SERVICE BULLETIN

SERVICE BULLETIN		No.: MSB-98E00-503	
		Date: 1998-12-15	<Model> <M/Y>
Subject: CORRECTION TO DIAGNOSIS CODE READING PROCEDURE FOLLOWED WHEN USING WARNING LAMP		(EC,EXP)COLT (CA0A,CC0A) (EC,EXP)	96-10 97-10 97-10
Group: GENERAL		Draft No.: 98AL051414	
CORRECTION	OVERSEAS SERVICE DEPT	 T.NITTA - VICE GENERAL MANAGER QUALITY INFORMATION ANALYSIS	(EC,EXP)L200(K00) (EC,EXP)LANCER (CB0A,CD0A)

This Service Bulletin informs you of correction to the diagnosis code reading procedure to be followed when using the warning lamp.

Indication of diagnosis code by warning lamp

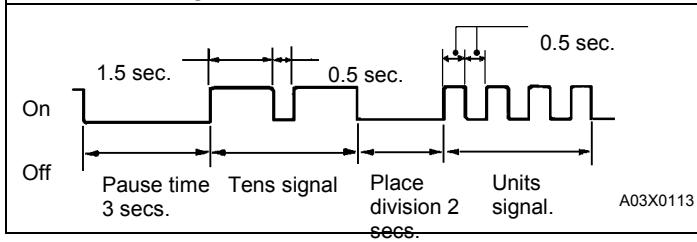
<Incorrect>

3. Turn off the ignition switch.
4. Read out a diagnosis code by observing how the warning lamp flashes.

ON

<Correct>
